**Marathon Petroleum Company LP
Detroit, Michigan**

RESPONSE TO COMMENTS DOCUMENT

May 26, 2016

PERMIT Nos. 118-15 and 122-15

Figure 2. SO₂ 3-Year Average of 99th Percentile Maximum Daily 1 Hour at Detroit – W. Fort Street (Southwestern High School)

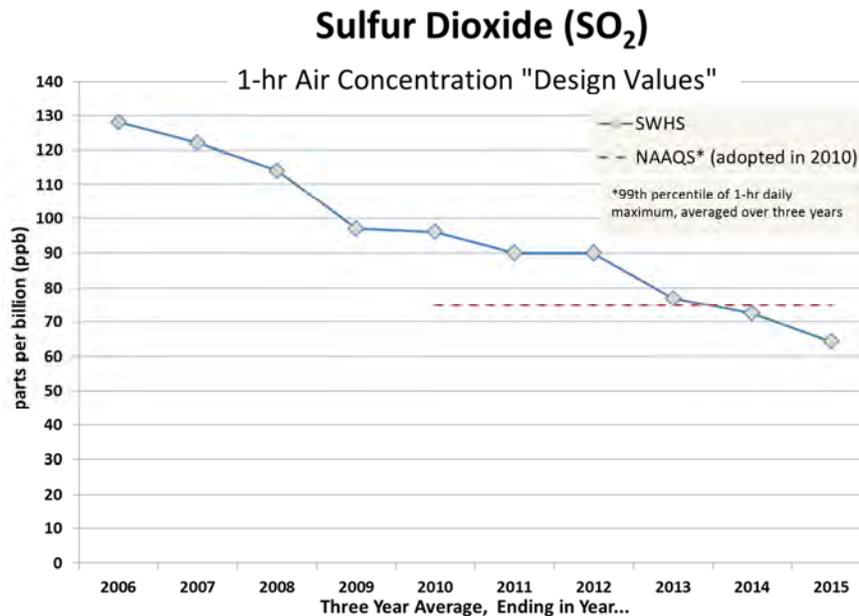
In addition, the ambient monitoring data show high levels of SO₂; 108 ppb at one of the Marathon monitors and a little lower at Southwestern High School; it is affecting people's health.

While it is true that the SO₂ monitor at Southwestern High School has shown hourly numbers above the NAAQS of 75 ppb, the most recent data shows that the 75 ppb NAAQS is now being met (see Figure 2).
